Subject: SAP Addendum for Additional Delineation Sampling, Reservoir No. 2 Burning Ground, Plum Brook Ordnance Works

Addendum to the Site Specific Sampling Plan

Engineering Evaluation/Cost Analysis Reservoir No. 2 Burning Ground

Figure A-1

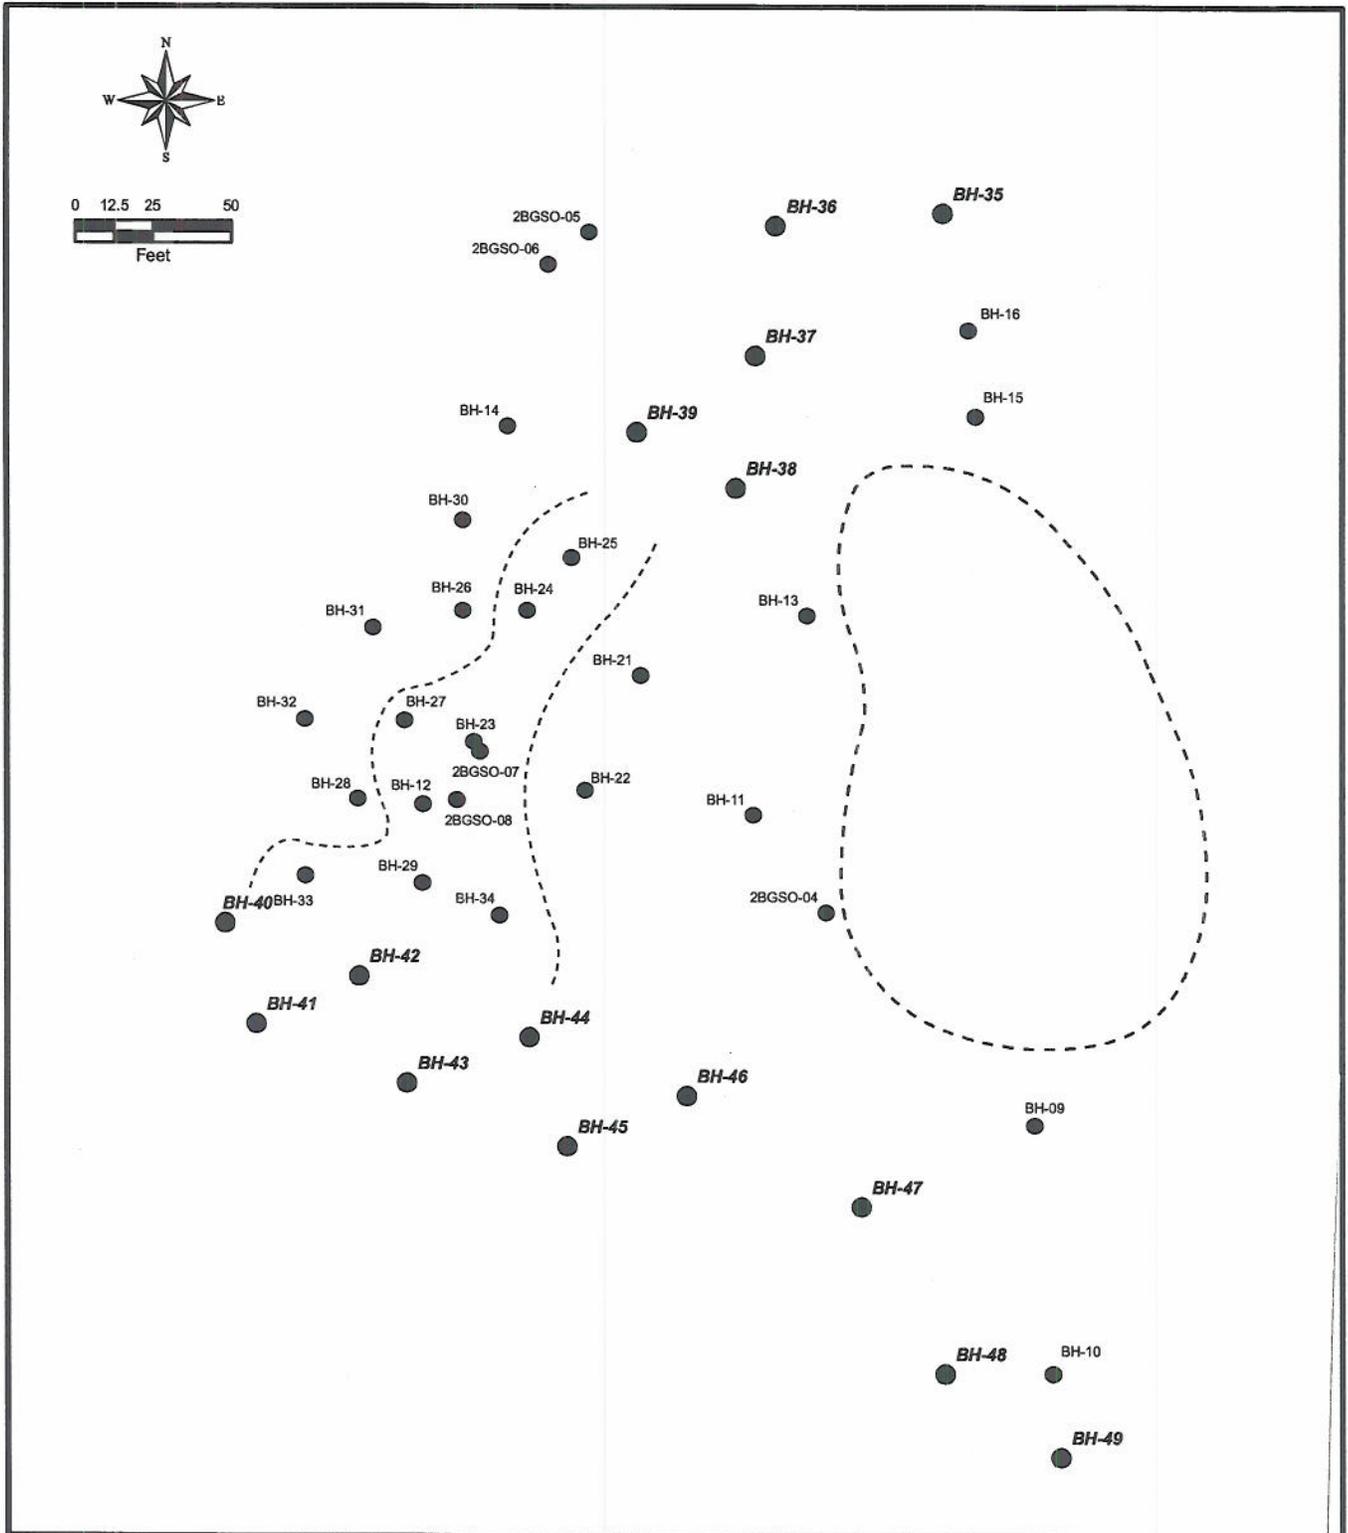
Fifteen additional surface soil locations are proposed, Figure A-1. The proposed locations have been selected to provide further delineation for the contamination areas. The additional locations have been placed at least 25 feet from the prior sampling points.
